AMENDMENT AND RESPONSE UNDER 37 CFR § 1.111

Serial Number: 09/320,421

Title: DRAM SENSE AMPLIFIER FOR LOW VOLTAGES

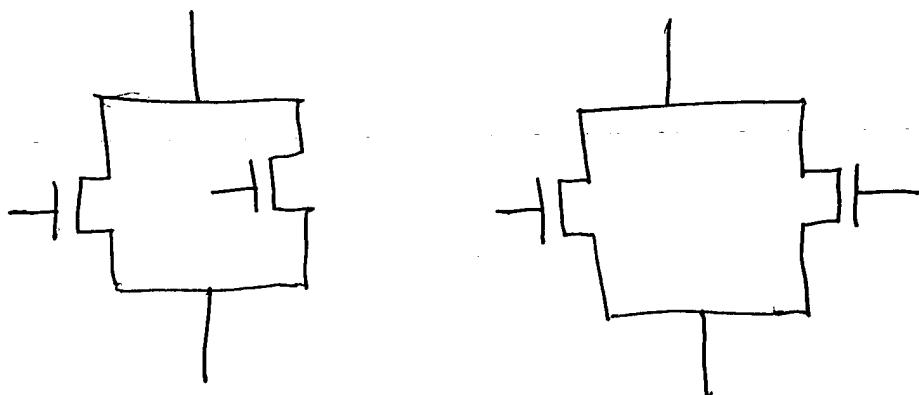
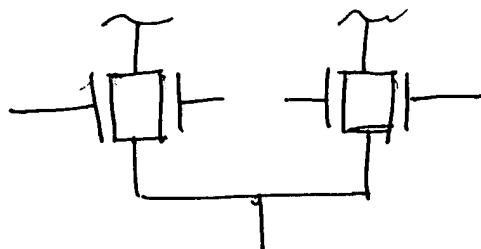
Kawashima discloses in figure 7 a sense amplifier (105) comprising: a pair of cross-coupled inverters (66-69, and 72-75), wherein each inverter includes: a transistor of a first conductivity type (66, 67), a dual gated transistor of second conductivity type (68, 69, 74, 75) wherein a drain region for the dual-gated transistor is coupled to a drain region of the transistor of the first conductivity type; a pair of bit lines (IN, /IN), wherein each one of the pair of bit lines is coupled to a first gate of the dual-gated transistor in each inverter; and a pair of bit lines is coupled to a first gate of the dual-gated transistor in each inverter; and a pair of output transmission lines (OUT, /OUT), wherein each one of the pair of output transmission lines is coupled to the drain region of the dual-gated transistor and the drain region of the transistor of the first conductivity type in each inverter.

This means, in effect, that two separate n-channel regions are formed in the single body region on opposing sides of the body region by independent potentials applied to the dual gates, and not that there are two physically separate transistors. Kawashima illustrates in the representation of transistors 68, 69, 74, and 75, a set of conventional separate NMOSFETs connected in parallel. The sketches below illustrate the same.

The sketch above represents either dual gated transistor (M3, M5) or dual gated transistor (M4, M6). The “box-like” structure with gates on both sides is clearly meant to designate a dual-gated or double-gated NMOSFET having a singly body region, and not simply two separate MOSFETS which would be more typically represented by the earlier sketches above. This structure can be further understood by reference to US patent number 6,104,068 which shares a common inventor to the present case. The terms “dual-gate” or “double-gate” are both commonly used in silicon technology for gates on opposing sides of a single body region and distinguish from reference to transistors simply connected in parallel as shown in Kawashima. This description of a dual-gate transistor is further to be distinguished from denoting a “dual-gate” MESFET transistor which have gates in series on only one side of a single transistor body region and which are used with microwave devices to perform an AND function circuit.

Kawashima appears to describe an amplifier and semiconductor memory device having the same. The amplifier is coupled to first and second power supply lines. Kawashima further describes a first pair of cross-coupled transistors connected to the first power supply line and a pair of output terminal, and a second pair of cross-coupled transistors connected to the second power supply line. The amplifier includes a pair of **input transistors** (e.g. 74 and 75, which are separate transistor structures altogether and do not share a single body region) connected to the second pair of cross-coupled transistors. (See Abstract). Kawashima does **not** describe a **dual gated transistor of a second conductivity type** as pointed to by the examiner at 68, 69, 74, and 75. Rather, the transistors referenced by the examiner include **four** independent transistor device structures coupled in parallel.

In contrast, each of the Applicant's independent claims recite a "dual gate transistor" as a positive limitation to the Applicant's invention. As used in the Applicant's specification, a "dual gate transistor" includes a transistor in which a single body region is driven on opposing sides by

two separate gates. This facilitates the high performance, wide bandwidth, or very fast CMOS amplifier of the present invention which is as much as 100 times faster than conventional voltage sense amplifiers when low power voltage supplies of less than 1.0 Volts are utilized. The same is explained in more detail in connection with Figure 2C. As outlined in the Applicant's specification on page 10, lines 16-30, the pair of transistors, (the first being M3, M5 and the second being M4, M6) in each inverter, B1 and B2, comprise a **dual gated** metal oxide semiconductor field effect transistor (MOSFET). One of the pair of transmission lines is coupled to a first gate of the dual-gated MOSFET in each inverter, B1 and B2. The transistor of a first conductivity type includes a p-channel metal oxide semiconductor (PMOS) transistor, and the dual gated MOSFET of a second conductivity type is divided into two separate n-channel metal oxide semiconductor (NMOS) transistors, each driven by one of the dual gates. The drain regions, 204 and 212, for one of the cross-coupled inverters, B1, is further coupled to a gate of the transistor of the first conductivity type, M2, and to a second gate of the dual-gated MOSFET in the other one of the cross-coupled inverters, B1 and B2. Similarly, the drain regions, 206 and 214, for inverter, B2, is coupled to a gate of the transistor of the first conductivity type, M1, and to a second gate of the dual-gated MOSFET in the other one of the cross-coupled inverters, B1 and B2.

In sum, Kawashima does not teach or suggest a “dual-gated” transistor as described herein in connection with the Applicant’s specification, drawings, and as claimed in each of the Applicant’s independent claims. Thus, the Kawashima reference does not include each and every limitation of the Applicant’s independent claims. Accordingly reconsideration and withdrawal of the 102 rejection for each of the Applicant’s independent claims, as well as those claims which depend therefrom, is respectfully requested.
